Subject: RATTLE / KNOCK NOISE FROM FRONT DISC BRAKE CALIPER	Bulletin No.: 04-005/19
	Last Issued: 09/24/2019

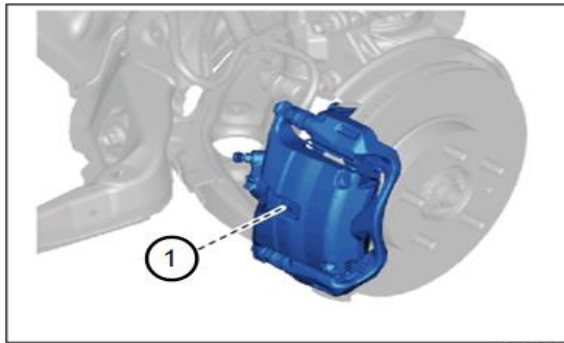
Some vehicles may exhibit a rattle / knock noise from the front disc brake caliper (1) when driving on a rough road surface.

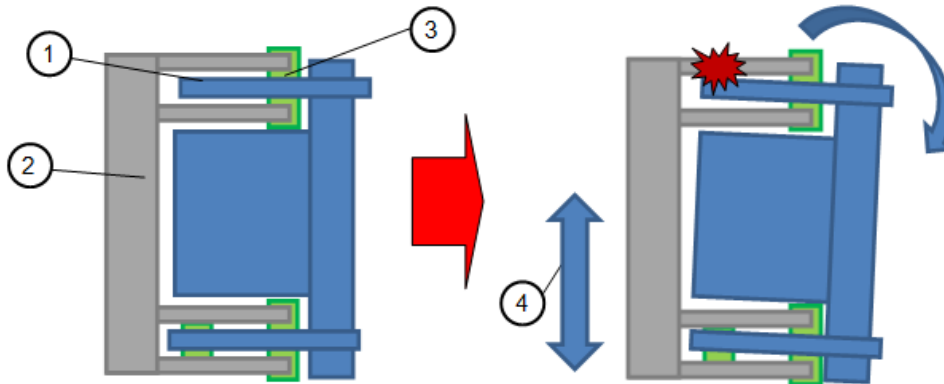
This is caused by the slide pin (1) hitting the mounting support (2) due to insufficient holding power of the dust boots (3) when a shock (4) is applied from the road. To eliminate this concern, the dust boots have been modified to increase holding power.

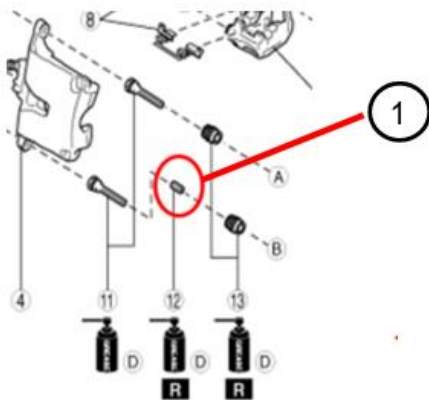
1. Verify the customer concern.
2. Replace the dust boots on **both sides** with modified ones according to the instructions on MGSS.

NOTE: Reuse the lower slide pin bushing (1).
